ADDENDUM #01

BLDG. 'A' & 'B' ELECTRICAL DEMOLITION PLAN

RUTH HARDING SCHOOL MODERNIZATION
3201 PICO ST.
FOR
BAKERSFIELD CITY SCHOOL DISTRICT
BAKERSFIELD, KERN COUNTY, CALIFORNIA

BUILDING 'A' AND BUILDING 'B' ELECTRICAL DEMOLITION PLAN

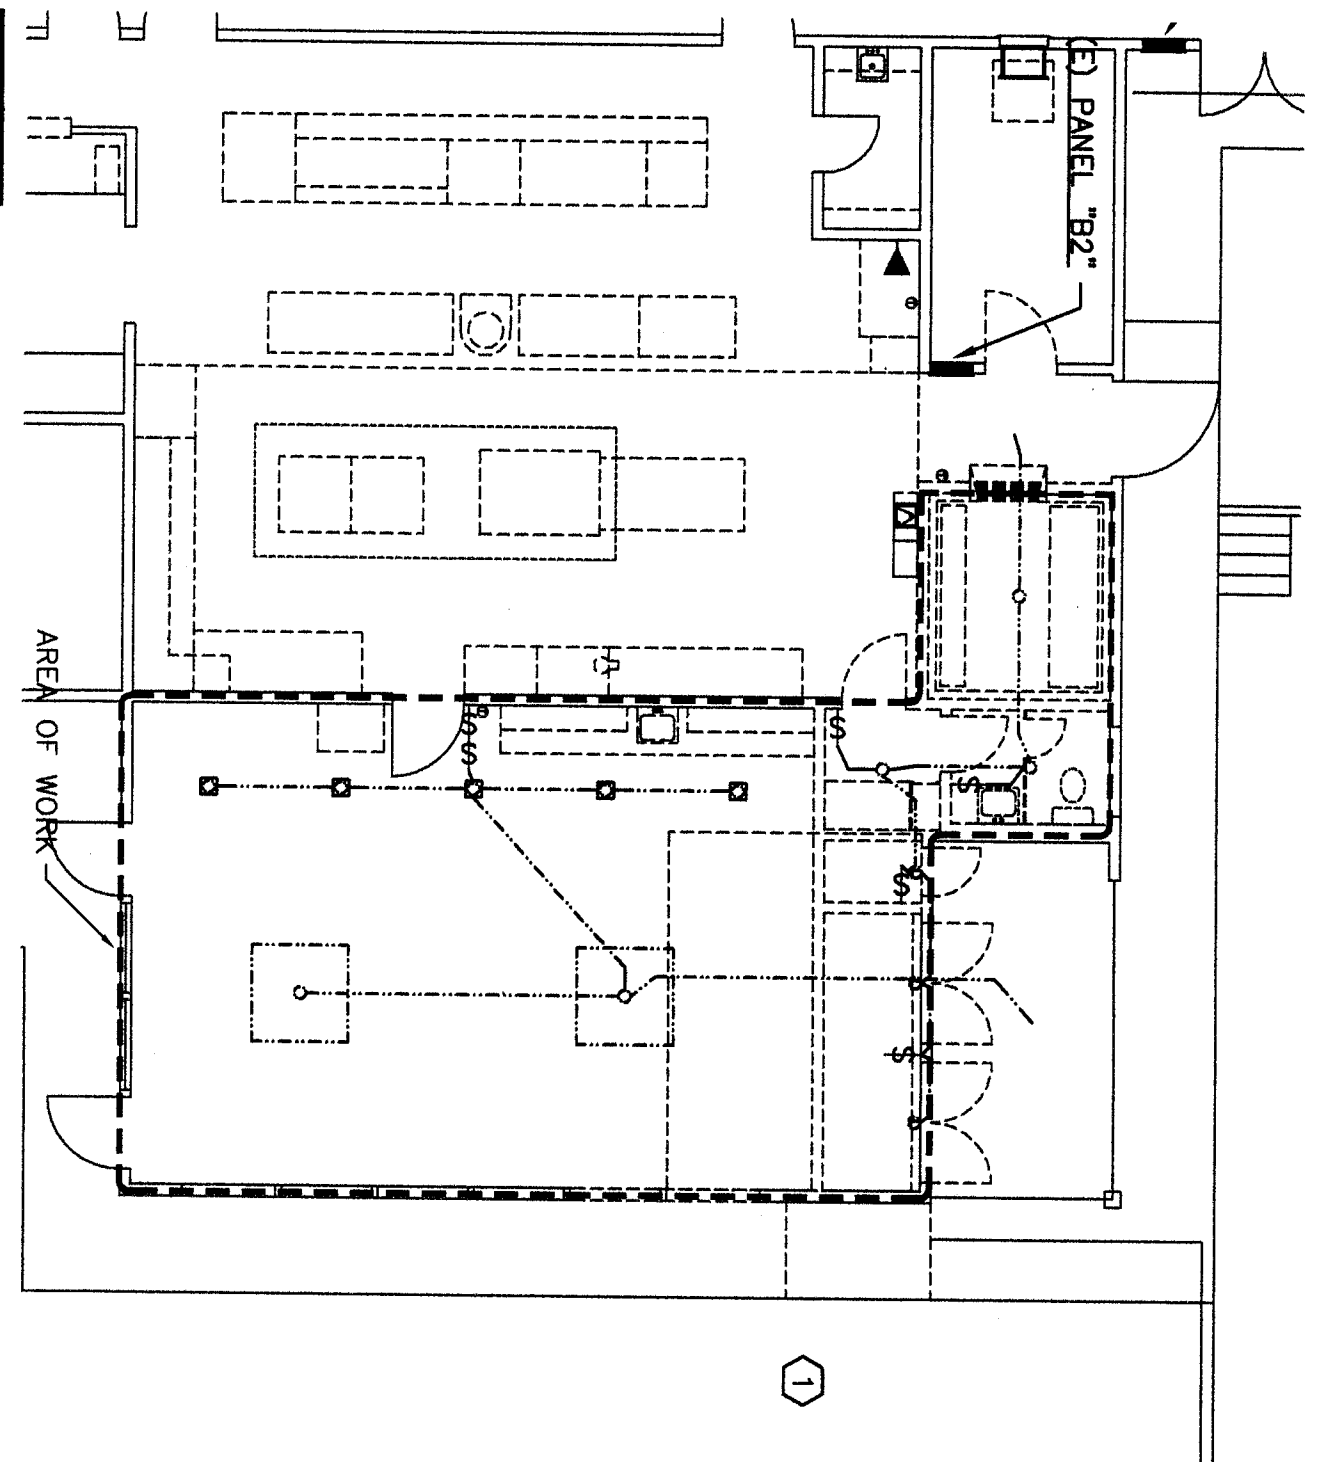
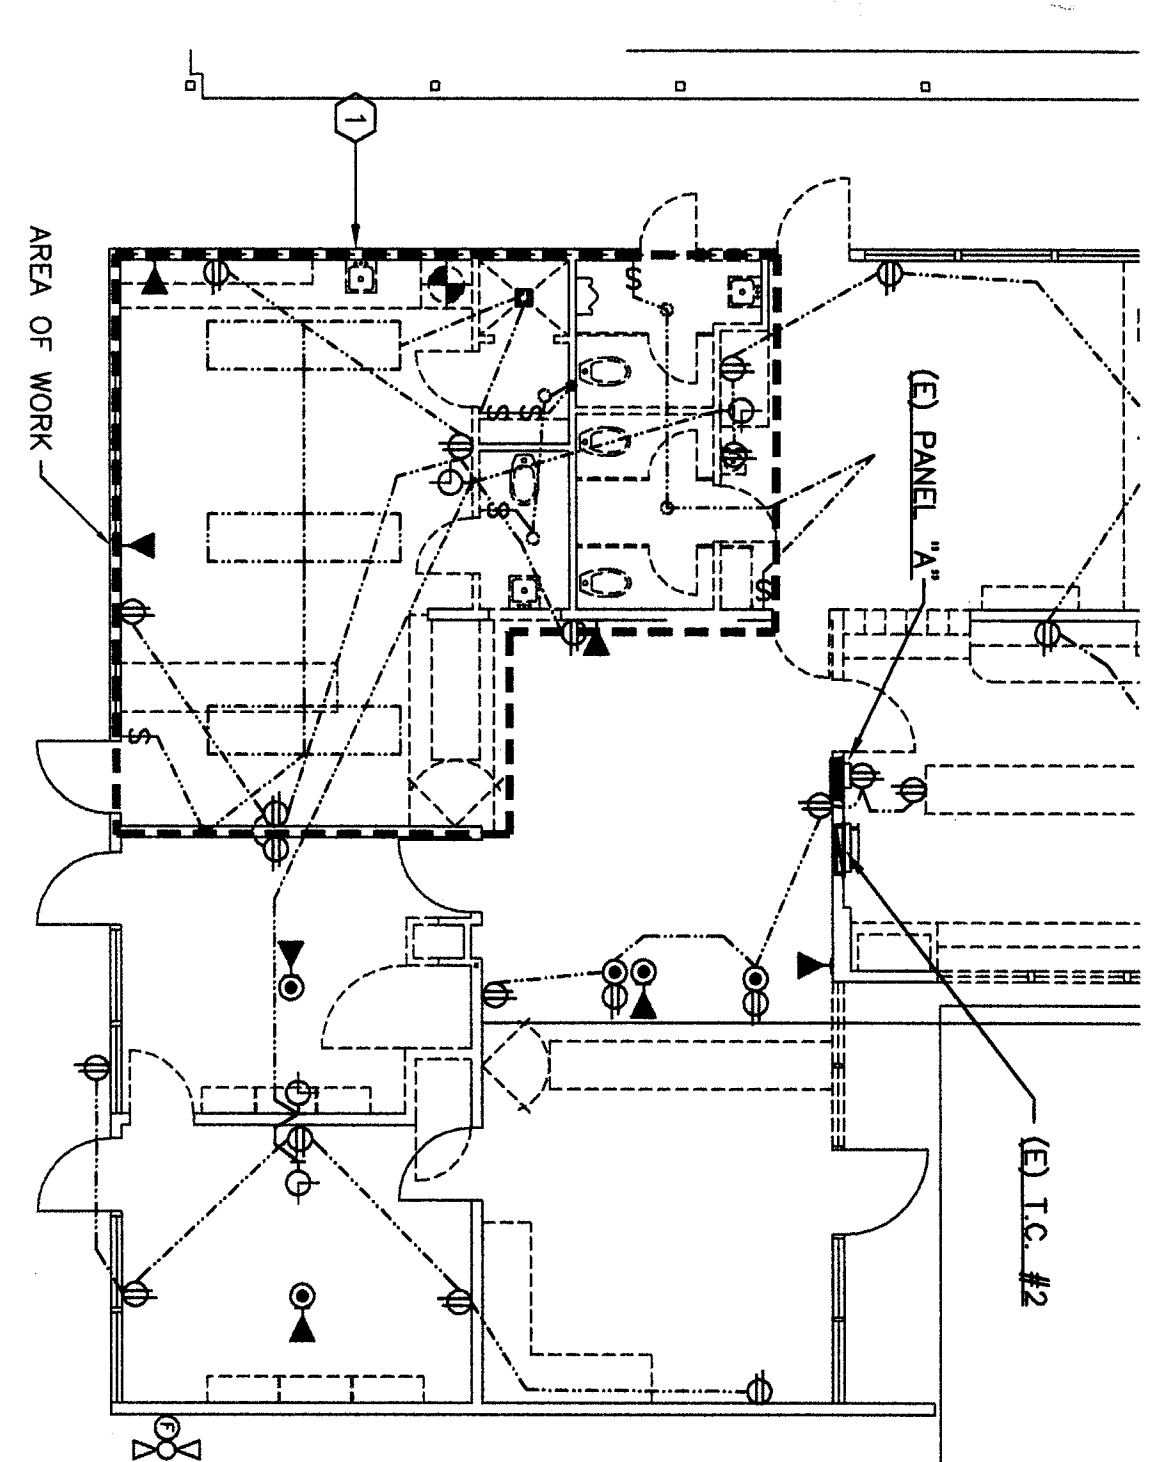
40. Refer to Electrical Drawing E2.0, Buildings 'A', and 'B' Demolition Plan.
a. REVISE:
#10
#11
Area of demolition in Buildings 'A' and 'B' shall be reduced as indicated in addendum drawing ADE-01 and ADE-02. Areas outside of work shall be removed as indicated. Temporary connections shall be made to maintain continuity of circuits effected by demolition.
